## CO87 – Appalachian Mountain Advocates (on behalf of 15 groups)

UNITED STATES OF AMERICA  
BEFORE THE  
FEDERAL ENERGY REGULATORY COMMISSION

Docket Nos. CP15-554-000,  
CP15-554-001, CP15-555-000

COMMENTS ON THE DRAFT ENVIRONMENTAL IMPACT STATEMENT  
FOR THE PROPOSED ATLANTIC COAST PIPELINE AND SUPPLY  
HEADER PROJECT

Figure IV(a): Northern Bath County intact forest landscape with pipeline route and proposed alternate routes.<sup>241</sup>

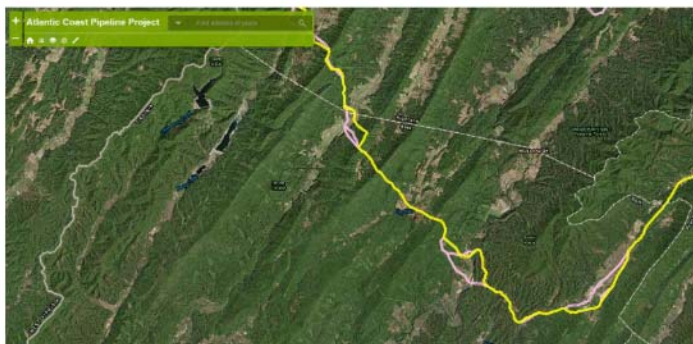
**b. The Commission fails to recognize that forests in Nelson and Highland Counties are on the cusp of losing forest connectivity if the pipeline is built.**

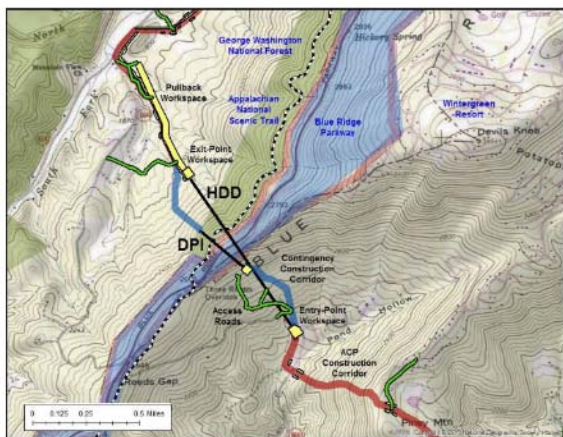
The HDD operation would involve drilling for 4,639 feet at 800 feet below the crest of the Blue Ridge.<sup>496</sup> The contingency DPI operation would involve drilling for 1,396 feet at 200 feet below the crest.<sup>497</sup> Both methods are commonly used for installing pipelines under rivers or other obstacles where the terrain is relatively flat and extremely hard or fractured bedrock is not encountered. The use of either method to drill for long distances through steep mountains is less

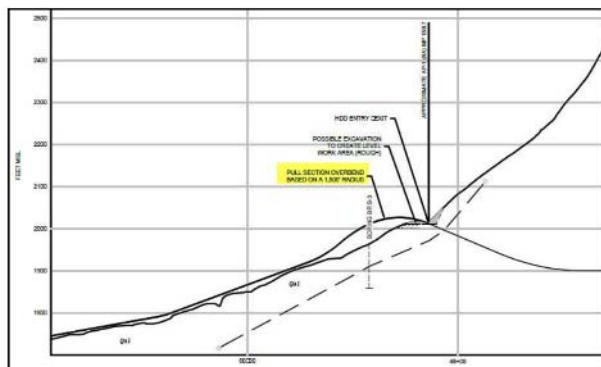
This differs substantially from the correct 4,200-foot bending radius. As indicated in the depiction, a shorter bending radius would require much less lifting of the pipe. The necessary elevation would only be about 50 feet compared to about 200 feet for the longer correct bending radius. The length of pipe suspension would also be much less.

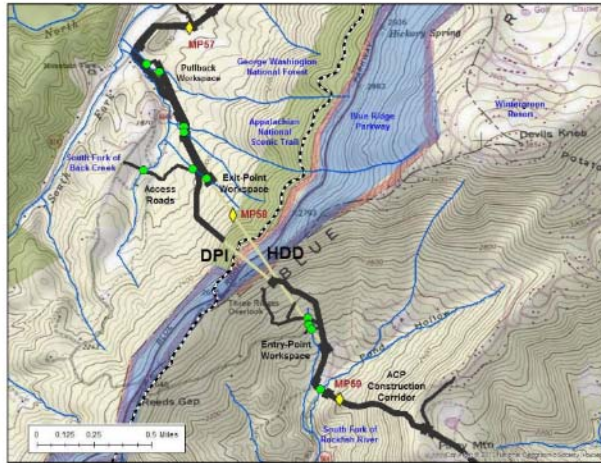
The indicated time-of-year restrictions for these streams limits work from October 1 to March 31 to protect sensitive life stages of aquatic life (see Section 5.1). Adherence to time-of-year restrictions conflicts with Atlantic's plans for wintertime construction. Information submitted by Atlantic to the National Park Service does not correlate with the stream crossing information depicted in **Figure**

FIGURE VII(i) – Recommended exit-side and pullback pipe fabrication workspace.

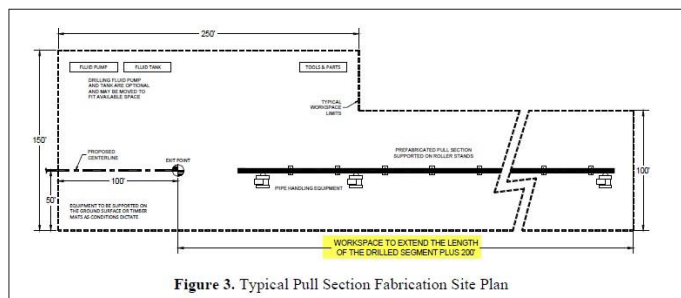
The HDD design report prepared for Atlantic by J.D. Hair & Associates, Inc. includes the following statement on pullback workspace requirements: "It is preferable to have workspace aligned with the drilled segment extending back from the exit point the length of the pull section plus approximately 200 feet. This will allow the pull section to be prefabricated in one continuous length prior to installation. If space is not available, the pull section may be fabricated in two or more sections which are welded together during installation. It should be noted that delays associated with joining multiple pipe strings during pullback can increase the risk of the pipe becoming stuck in the hole. . . . A typical pull section fabrication site plan is shown in Figure 3 [see **Figure VII(i)**]. Where possible, we recommend obtaining workspaces of similar dimensions to accommodate HDD pipe side operations on the ACP Project."<sup>516</sup>

FIGURE VII(k) – Locations of subsurface borings and geophysical surveys conducted for the proposed Blue Ridge HDD crossing. From Geotechnical Site Investigation Report for Atlantic Coast Pipeline Horizontal Directionally Drilled Crossing, Blue Ridge Parkway, Segment AP-1

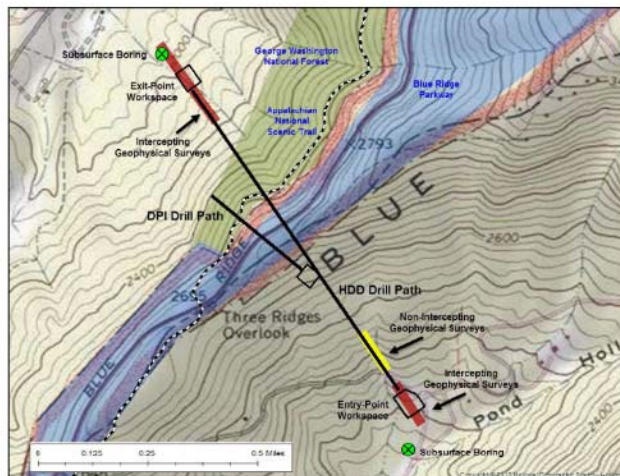
Commission by Atlantic, only two subsurface borings were completed for the proposed HDD, and both were at a lower elevation than the proposed HDD drill path. The only direct physical measurement of geotechnical properties or groundwater in the HDD area was provided by these borings. There were no subsurface borings in the area of the contingency DPI. Additional investigation using geophysical survey methods was limited to areas close to the HDD entry and exit points, covering only a small part of the projected drill path. The locations of the two subsurface borings and other geophysical surveys for the HDD are indicated in **Figure VII(k)**.

**FIGURE VII(l)** – Interpreted results of geophysical surveys conducted at the entry- and exit-sides of the proposed HDD drill path. (Based on Geophysical Study for a Proposed Blue Ridge HDD Crossing Augusta and Nelson Counties, Virginia, prepared by ATS International, Inc., 4/12/16.)

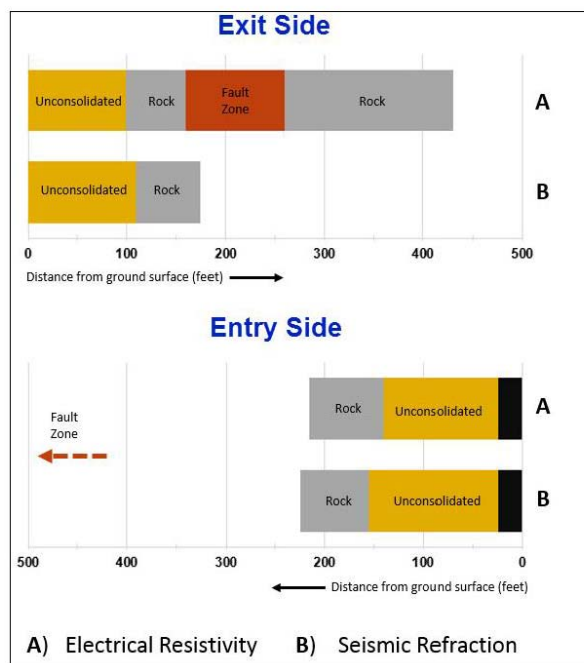
Results are shown for survey sections where imaging intercepted the projected drilling path. The fault zone in the entry-side section was estimated based on non-intercepting surveys, and was estimated to begin at 425-550 feet from the ground surface. The black-colored segments starting at the ground surface on the entry side indicate planned excavation. The total length of the projected drill path is 4,639 feet.

FIGURE VII(m) – Construction-area slope and access-road grade classification for the Blue Ridge HDD and contingency DPI operations area.

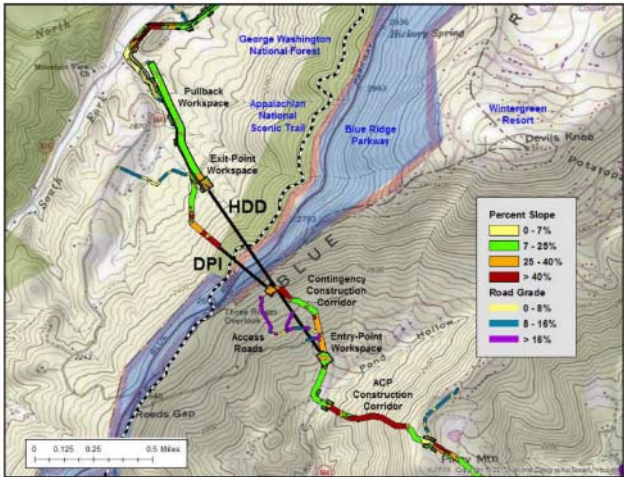
- Slope classification for the corridor and workspace areas is based on the following spacing criteria for right-of-way or runoff diversions (Virginia Erosion and Sediment Control Handbook, 1992).

Figure XVI(a): Unconventional Wells Drilled in  
Ohio, Pennsylvania, and West Virginia (2004-2015).<sup>827</sup>

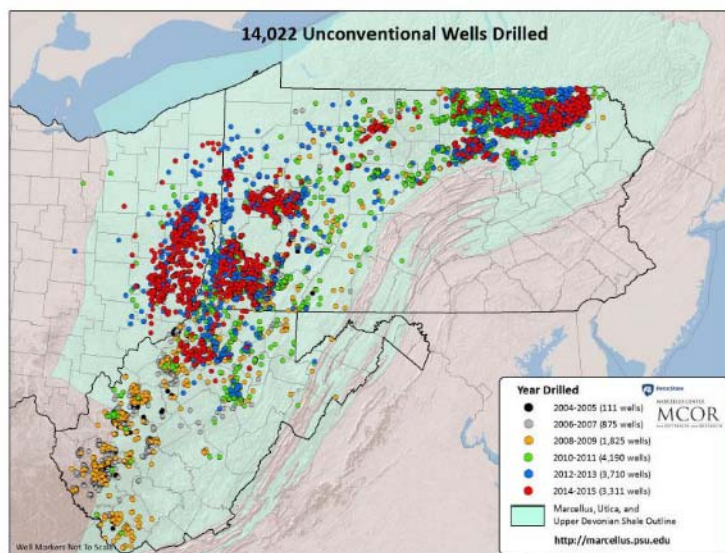
FERC claims that although it “[was] able to estimate the amount of land that would be disturbed” by shale gas development, because it does not know the precise classification of the land affected by shale gas development, “it [was] only possible to speak in general terms about the cumulative effects on specific

Figure XVI(b): Total Confirmed Bobcat Observations, 2006-2011.<sup>896</sup>

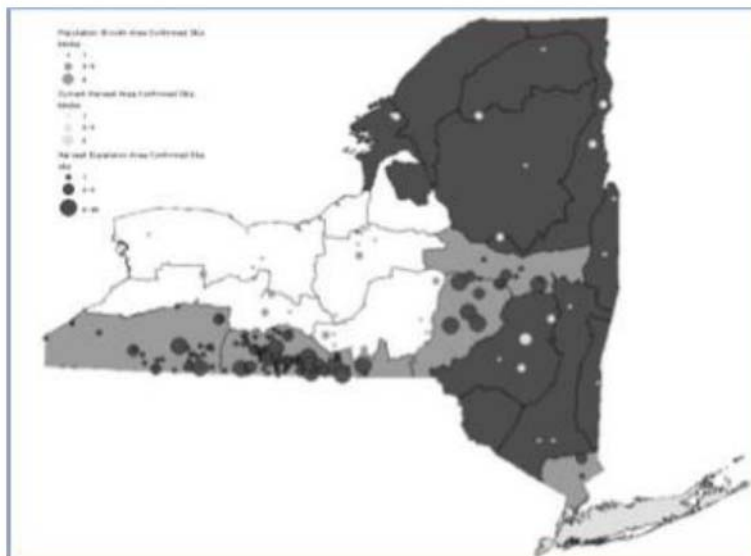
While NYDEC was documenting an increase in bobcat observations in the southern tier of New York between 2006-2011, hundreds and then thousands of shale gas wells were being drilled in the northern tier of Pennsylvania. As Figure

**Figure XVI(c): Unconventional Wells Drilled in Pennsylvania (2004-2015).<sup>897</sup>**

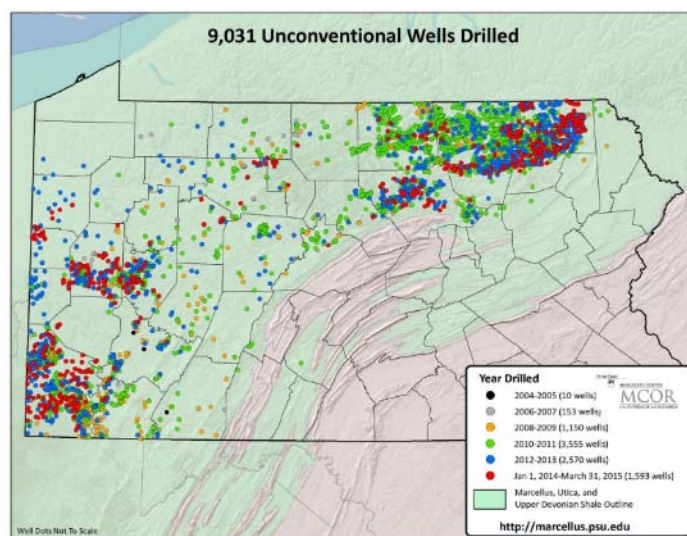
XVI(c) indicates, between 2006-2011, gas companies drilled at least 4,858 shale gas wells in Pennsylvania.

Many of these wells were drilled in Pennsylvania's northern tier. Thus, at the same time the gas industry began and then rapidly escalated gas drilling across the northern tier of Pennsylvania, the bobcat population in the southern tier of
